July 11, 2008 (first responses)

October 27, 2008 (second responses) 4

Energy Metals Corporation
Responses to NRC Request For Additional Information
Moore Ranch Uranium Project Source Material License Application

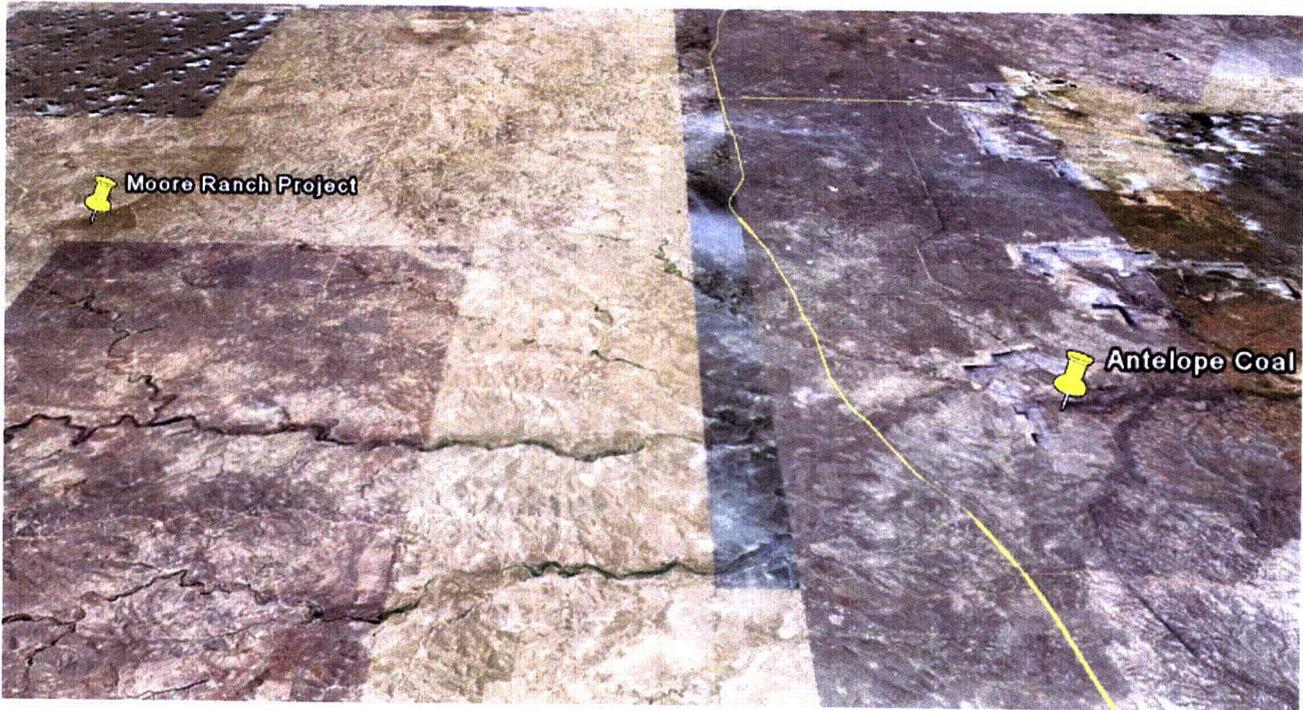
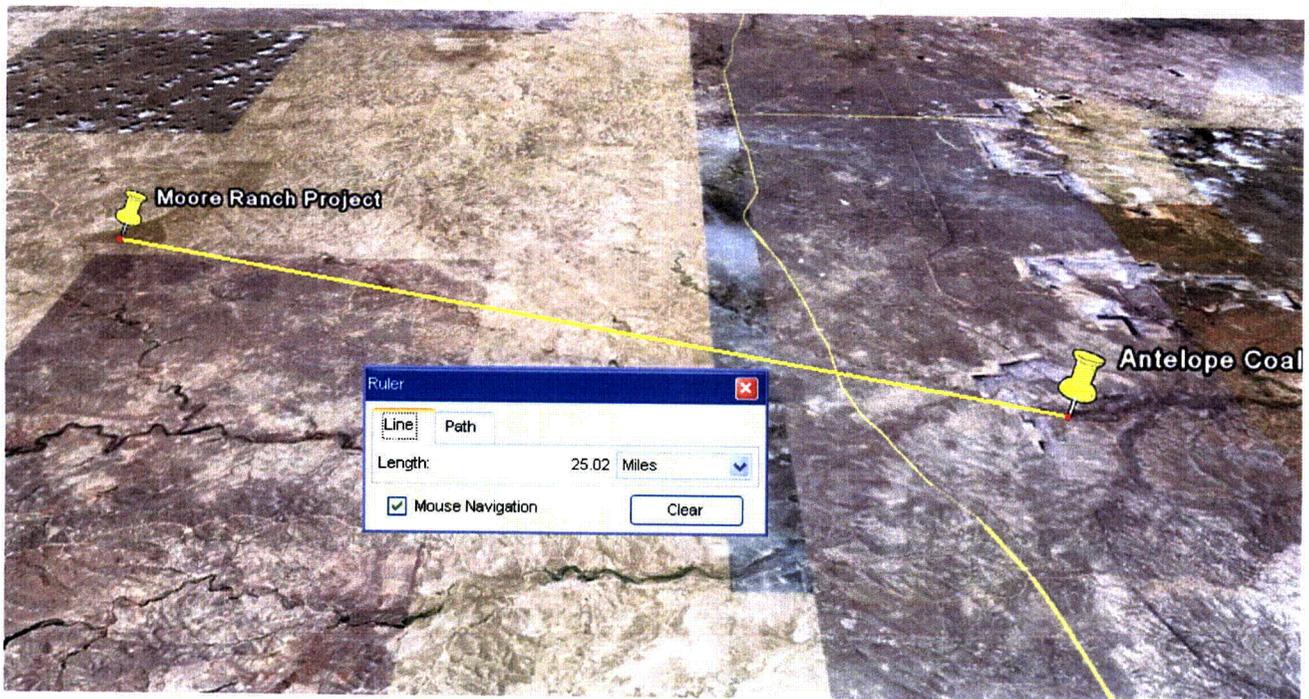
- a. The applicant indicated that no onsite meteorological data was collected at the Moore Ranch site but instead, used meteorological data collected from Antelope Coal (ACC) and Glenrock Coal (GCC) to represent the Moore Ranch site. However, the applicant has not discussed its basis to assume that the data can be used to represent the Moore Ranch site without any data from the Moore Ranch site. Therefore, provide the justification to use the data from these two sites (ACC and GCC), without onsite meteorological data, to represent the Moore Ranch site.

As stated in the conclusion of the Climatology Report, the Antelope Mine (ACC) meteorology most nearly represents that of the Moore Ranch project site, and is therefore proposed as the source of meteorological data to be substituted for on-site monitoring. Data from the Glenrock Mine (GCC) was intended only to supplement ACC and to support the general conclusions made regarding local meteorology. To illustrate the similarities between Moore Ranch and ACC, several images from Google Earth are presented below. Figure 2.2a-1 shows an aerial view of the Moore Ranch area, and Figure 2.2a-2 shows a similar view of the ACC site (with meteorological station pinpointed). The ACC site has similar topographic features (Figure 2.2a-3) and is about 25 miles from the project site (Figure 2.2a-4). Both sites are characterized by mildly rolling hills covered with grass and sparse shrubs. The nearest mountain ranges are:

- the Bighorn Mountains, approximately 50 miles from the Moore Ranch project site and 75 miles from ACC
- the Black Hills, approximately 60 miles from ACC and 85 miles from the Moore Ranch
- the northern Laramie Range, approximately 50 miles south of Moore Ranch and 65 miles southwest of ACC

Due to these large distances, neither the ACC site nor the Moore Ranch site experiences significant wind channeling or shielding from any of the three mountain ranges. Also, there are no major bodies of water affecting the meteorology of these two sites. The ACC site is several hundred feet lower in elevation than Moore Ranch. Both, however, are situated on the southeasterly side of the hydrologic divide with a similar vertical relationship to the divide.

Section 2.5 of the application was revised to include the above information.
